Field Service Bulletin Trucks

Date	Group	No.	Release	Page
10.2013	284	047	02	1(9)

Oil Level Sensor Harness Wire Splice
CHU, CXU, GU, LEU, MRU, TD

FSB 284-047, Oil Level Sensor Harness Wire Splice

Old Style Hollow Pin Connector

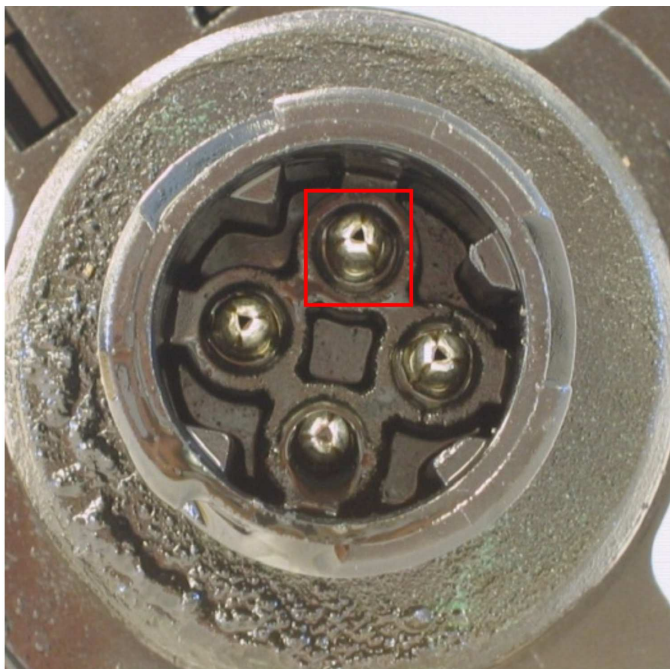
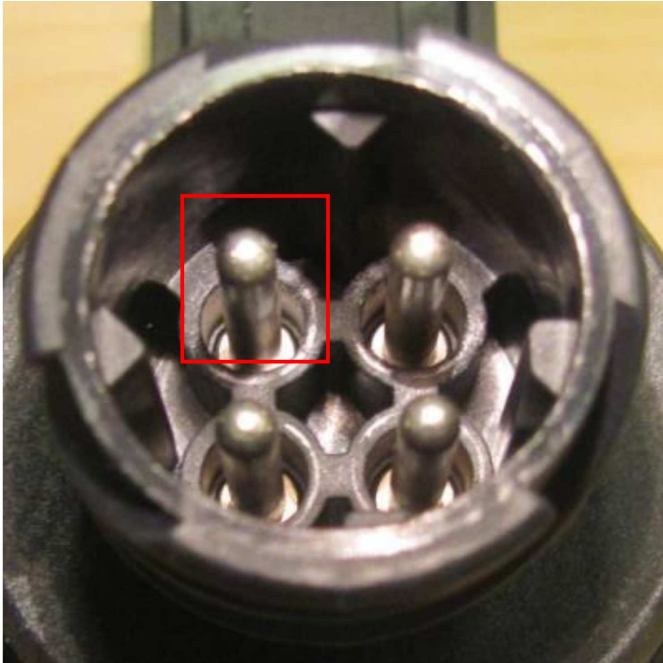
Some MACK vehicles with MP engines built between January 2004 and September 19, 2013 may experience an oil level sensor failure that leads to oil contamination into the engine wire harness. A new anti-wicking pigtail splice kit, part number 85137983, is now available. Follow the procedure below if wicking is observed. Chassis with build date September 20, 2013 and later have the new solid pin connector and no action is required. The oil level sensor part number 21521353 with hollow pin type connector is now replaced with the new solid pin type connector oil level sensor part number 22022794. The new solid pin connector does not allow oil to wick into the engine harness.

New Style Solid Pin Connector

If a sensor is being replaced for electrical faults and oil has not wicked into the harness, **REPLACE THE SENSOR ONLY.**

If a sensor has failed **AND** is wicking oil into the engine harness, **REPLACE THE SENSOR AND INSTALL THE PIGTAIL AS INSTRUCTED IN THIS BULLETIN.**

If the engine harness is being replaced for other reasons and the sensor connector is the older hollow pin type, **REPLACE THE SENSOR ONLY.** The new harness will **NOT** require the pigtail kit.
